Docket Item # 5 & 6
BAR CASE #2011-0305 & 306

BAR Meeting
November 16, 2011

ISSUE: Certificate of Appropriateness

LOCATION: 705 Bashford Lane

Figure 5: Proposed rear elevation.

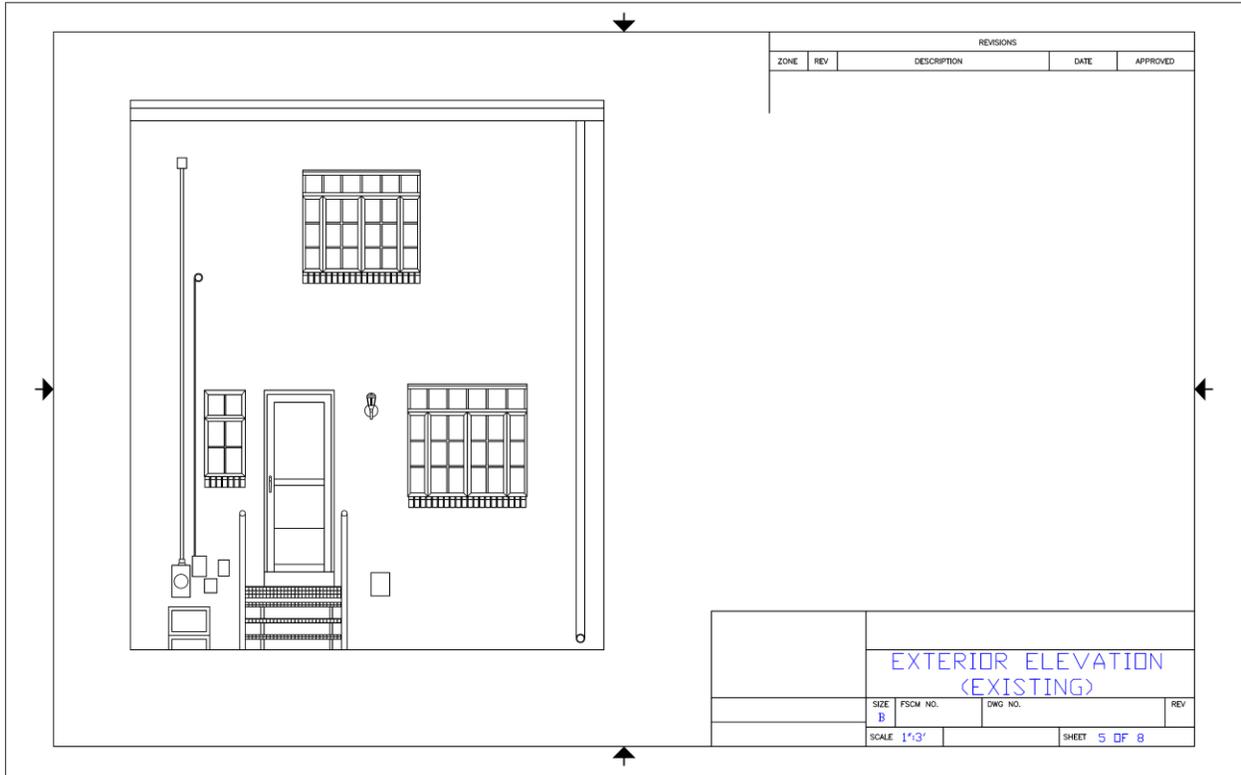
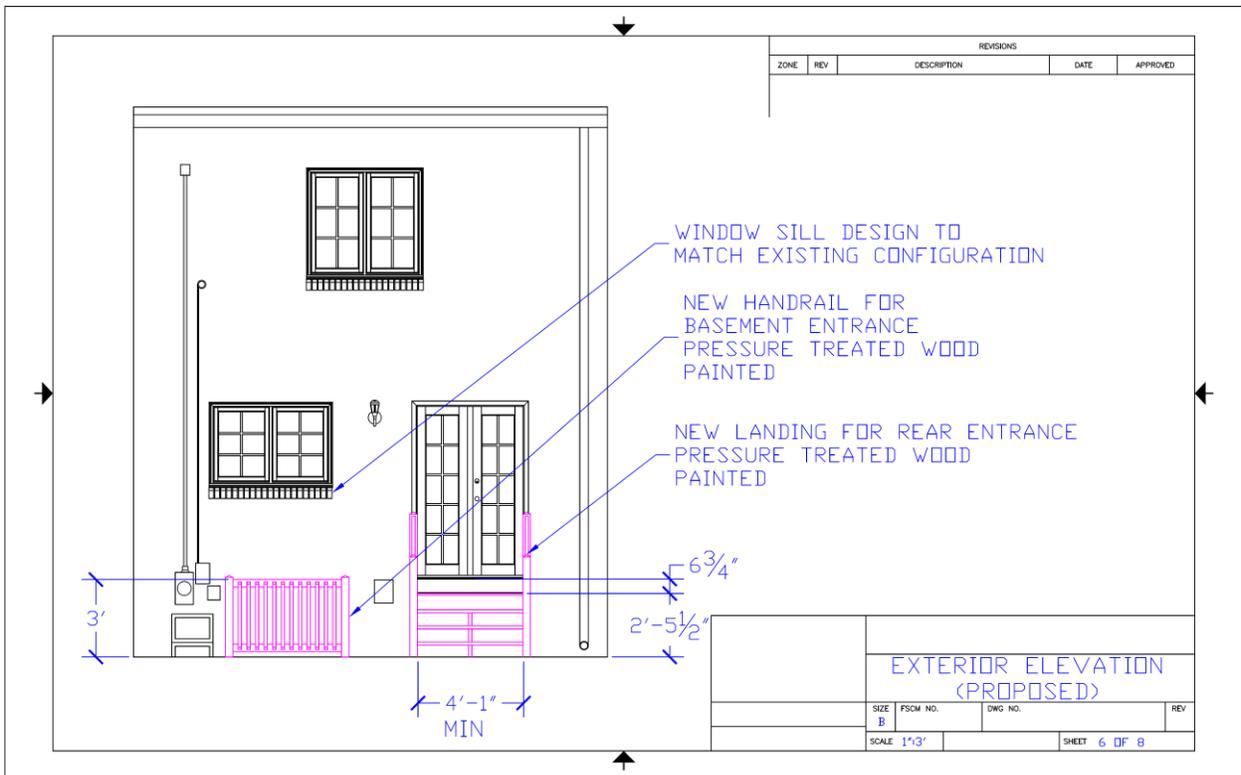
The applicant is requesting to reconfigure the door and window openings on the first floor of the rear elevation in order to accommodate an interior kitchen. Staff supports this alteration for the same reasons Staff supports the demolition. Staff however, recommends that the brick that is being removed from under the current (rear) first floor window is salvaged and used to fill in the area below the new window opening so that the bricks match the remainder of the façade. Staff also recommends that an appropriate mortar composition is used and that the mortar profile and color matches the existing.

1. That the brick that is being removed from under the current rear first floor window is salvaged and used to fill in the area below of new window opening;
2. That an appropriate mortar composition is used and that the mortar profile and color matches the existing;
3. That the window light configuration be changed to 12 lights per casement sash, or 24 equal lights total per window opening, to generally match the original light configuration of the metal casement windows;
4. That the window replacements comply with the *Alexandria Replacement Window Performance Specifications*.

Figure 6: Proposed area for demolition.

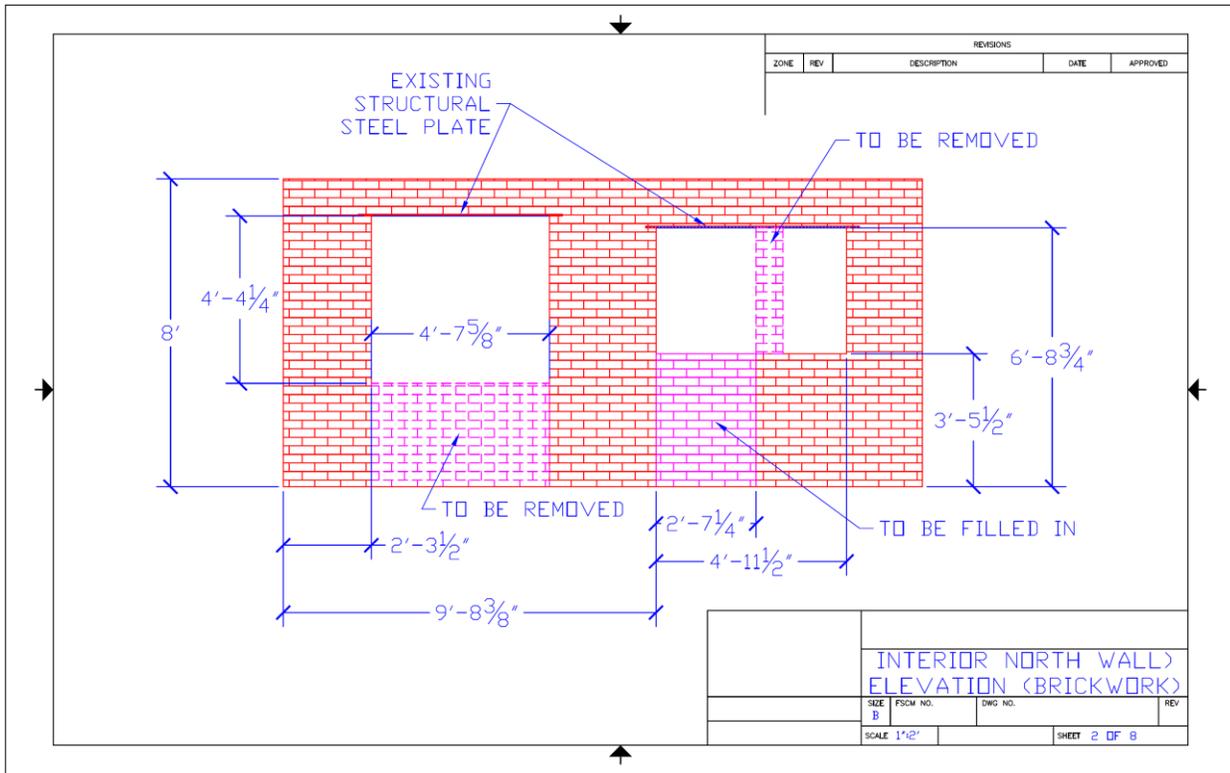
- Demolish the first floor rear window and the brick below it to accommodate a new French door opening (demolish approximately 31 square feet)
- Demolish the first floor rear door and side window to accommodate one new window opening (demolish approximately 25 square feet)

In the opinion of Staff, none of the criteria for demolition and encapsulation are met and the Permit to Demolish/Encapsulate should be granted. Staff has no objection to the proposed demolition and reconfiguration to portions of the rear and finds the proposed changes to be compatible with the existing building. The area proposed for demolition/encapsulation is minimal in scope, located on a secondary elevation, and does not compromise the integrity of this early-20th century townhouse or its neighbors.

Figure 7: Proposed stoop and guardrail drawings.

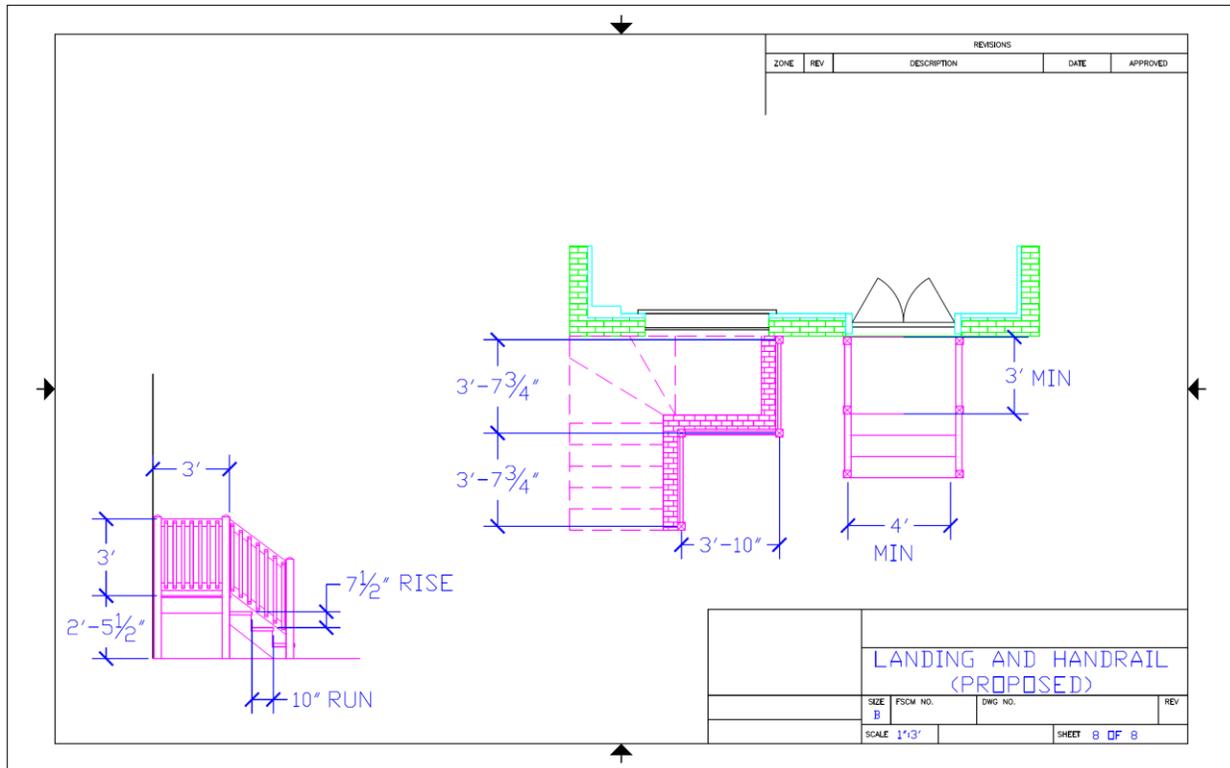
Due to the proposed relocation of the rear door and the increased size of the doors, the applicant is requesting a new stoop. The new stoop measures 5'5-1/2" high by approximately 4'1-1/2" wide and will be made of pressure treated wood, which will then be painted. The shift of the stoop exposes the drop-off of the basement entry, and therefore, the applicant is requesting to construct a wood guardrail for safety reasons. This guardrail will measure 3'0" high by 3'10" long and will also be made of pressure treated wood, which will be painted to match the stoop. The design of the stoop and guardrail is appropriate for this minimalistic secondary façade and utilizes appropriate materials for the time period. In addition, once the applicant installs a future privacy fence in the rear yard, these elements will not be visible from a public way. Staff recommends approval of both the wood stoop and wood guardrail.
